**Addendum I to
ASHRAE Guideline 36-2021**

Proposed Addendum I to Guideline 36-2021, High-Performance Sequences of Operation for HVAC Systems

**First Public Review (September 2024)
(Draft shows Proposed Changes to Current Guideline)**

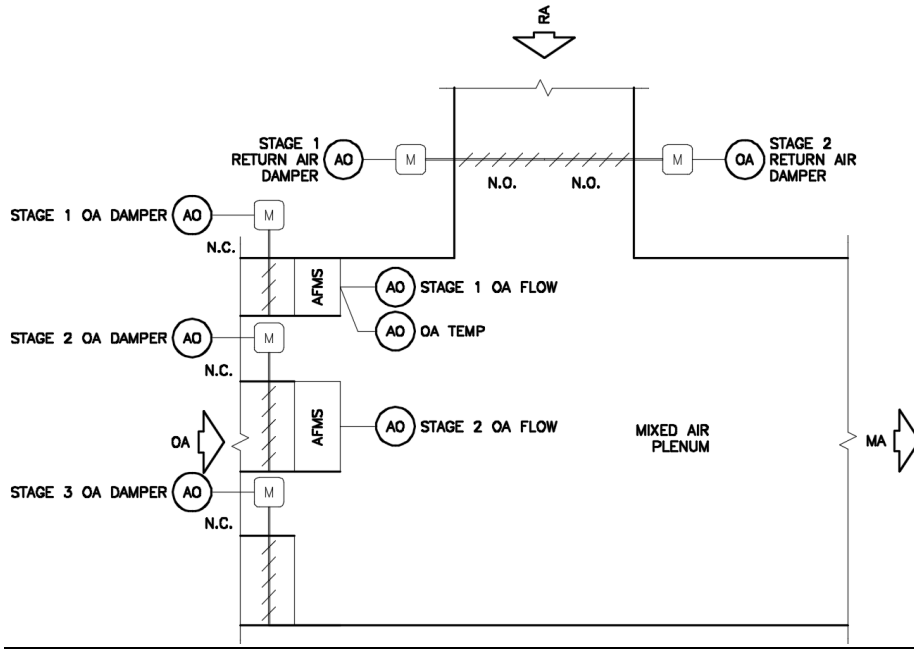
After 5.16.6 3.a. edit text as follows:

Include the following section if the air handling unit is very large and thus requires staged outdoor air damper/AFMS assemblies so that airflow measurement can be accurate when the AHU is serving small Zone Groups and/or due to many zones with CO₂ DCV, or occupancy sensors which can result in very low minimum outdoor air rate setpoints.

1. Stage each outdoor air economizer damper/AFMS assembly as follows:

Design drawings must clearly indicate which outdoor air damper/AFMS assembly corresponds to each stage. Fundamentally, the first stage must be the smallest outdoor air damper/AFMS assembly, and it should be located as close as possible to the first stage return air damper with parallel blade dampers directing the two airstreams at each other for best mixing. The second stage outdoor air damper/AFMS assembly is usually the next closest to the return air dampers, etc. AFMS need only be provided for each stage up to the AHU's design minimum outdoor air rate where accurate outdoor air rate measurement is needed to meet ventilation codes; for higher stages, AFMS may be deleted and the outdoor air rate through these stages assumed to have the same face velocity as the lower stages. Here is a typical design with 3 stages of outdoor air (with the first two having AFMS) and 2 stages of return air:

- i. All enabled outdoor air dampers receive the same AO signal.
- ii. Each damper/AFMS stage shall be enabled no less than 10 minutes before disabling. When changing stages, a ramp limit shall be placed on the damper AO signal to avoid instabilities. Staging timer does not start until ramp limit is finished.
- iii. Staging shall enable outdoor air dampers for damper/AFMS stage x as follows based on the current minimum outdoor air setpoint, MinOAsp, and actual outdoor air reading of all enabled AFMSs.
